UNITED STATES
NUCLEAR REGULATORY COMMISSION
WASHINGTON, D. C. 20555

SUBJECT: ACCEPTANCE FOR REFERENCING GENERAL ELECTRIC LICENSING TOPICAL
REPORT NEDO-24154/NEDE-24154P

SAFETY EVALUATION
FOR THE
GENERAL ELECTRIC TOPICAL REPORT
QUALIFICATION OF THE ONE-DIMENSIONAL
CORE TRANSIENT MODEL FOR
BOILING WATER REACTORS
NEEG-24154 and NEDE-24154-P
Volumes I, II and III

Figure 1 Axial Power Profile Turbine Trip 1

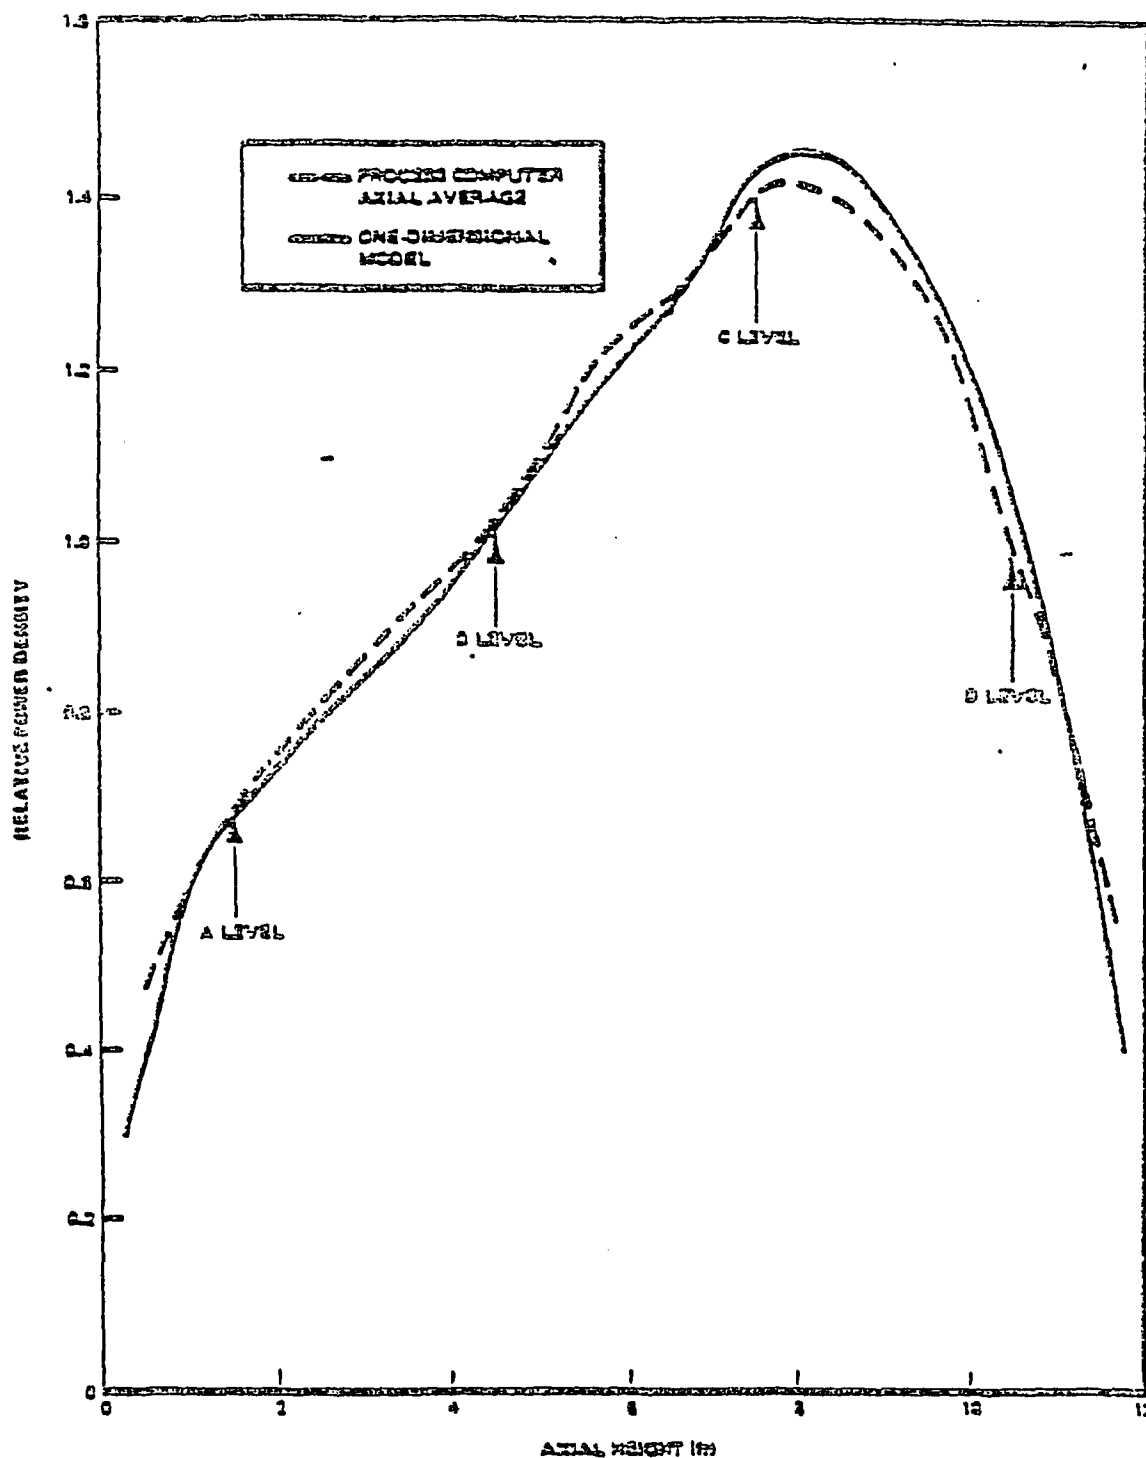
A further indication of the adequacy of the ODYN calculation can be ascertained by comparing the core power as a function of time at the Local Power Range Monitor (LPRM) detector positions. The miniature fission detectors that comprise this LPRM system are distributed both radially and axially within the reactor core. Analysis of the PB-2 data shows that the radial variation of the neutron power with

Figure 5 Peach Bottom-2 Turbine Trip 2 Reactor Neutron Power

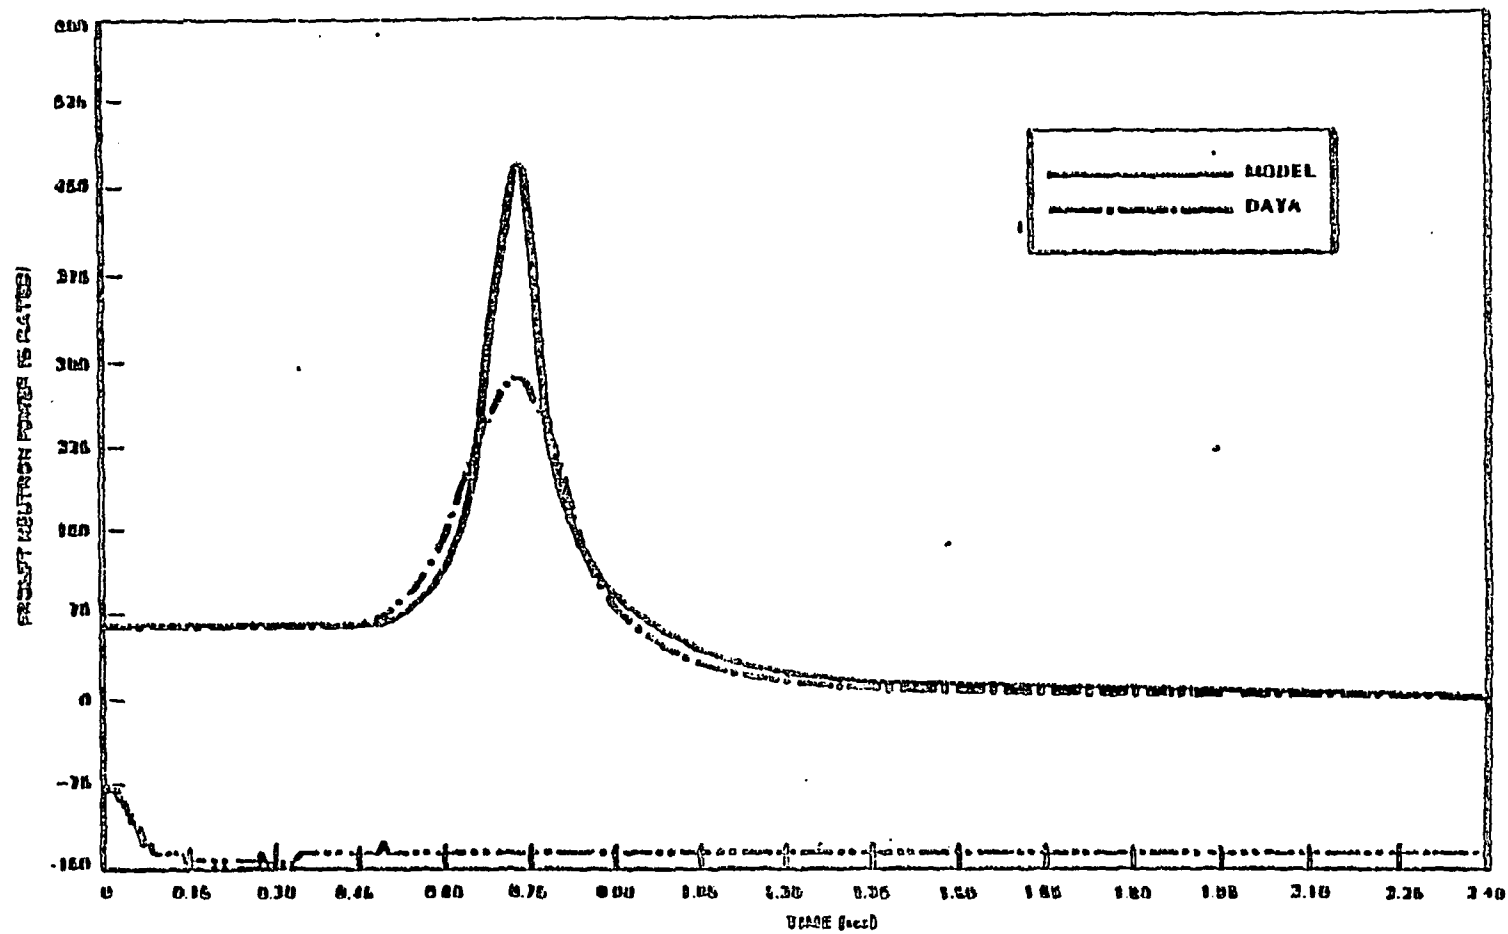
The neutron flux predictions by the ODYN code were conservative relative to data. We estimate that the peak neutron flux is higher by 34 to 25% than the data and the integral of the nuclear power (which is a measure of the amount of energy generated) is also higher by approximately 15 to 42% than the data. Hence, the neutron fluxes were predicted conservatively in all three tests.

Figure 8 EKKI Turbine Trip Prompt Neutron Power

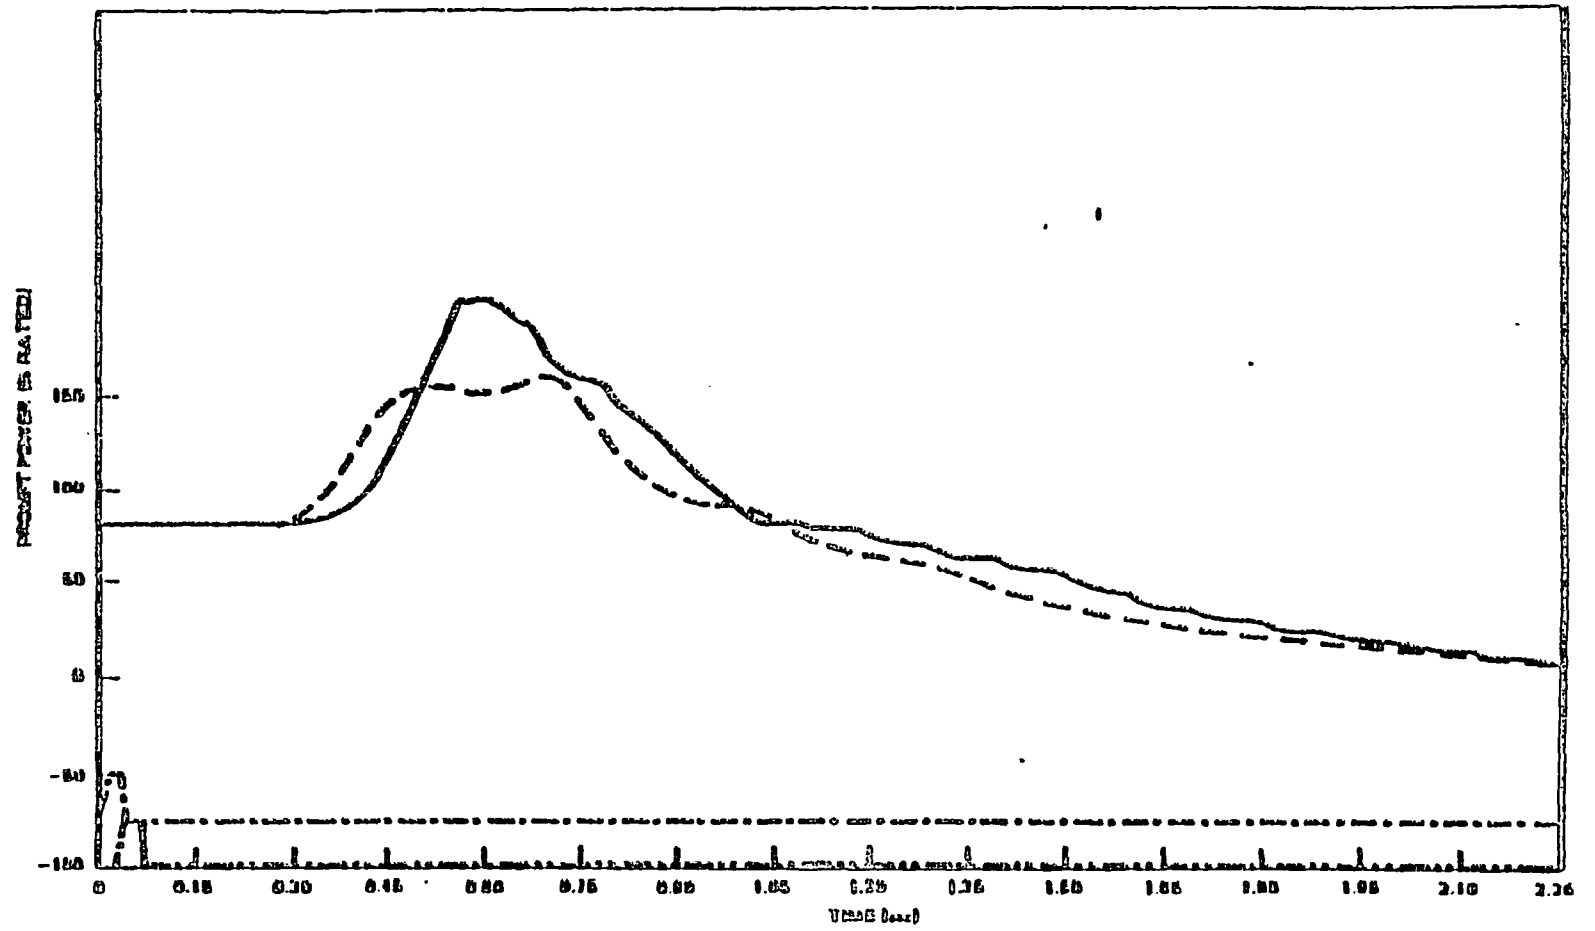
The measurement of neutron flux indicates a double peak behavior. This double peak was attributed to an oscillation in core pressure which was thought to be enhanced by KKH bypass characteristics. The ODYN code overpredicted the initial neutron flux peak by approximately 53% and underpredicted the second peak. We estimated that the integral of the calculated nuclear power was higher by approximately 20% than the data. Figures 7 and 8 present the comparisons of measured and calculated axial neutron and prompt neutron fluxes respectively.
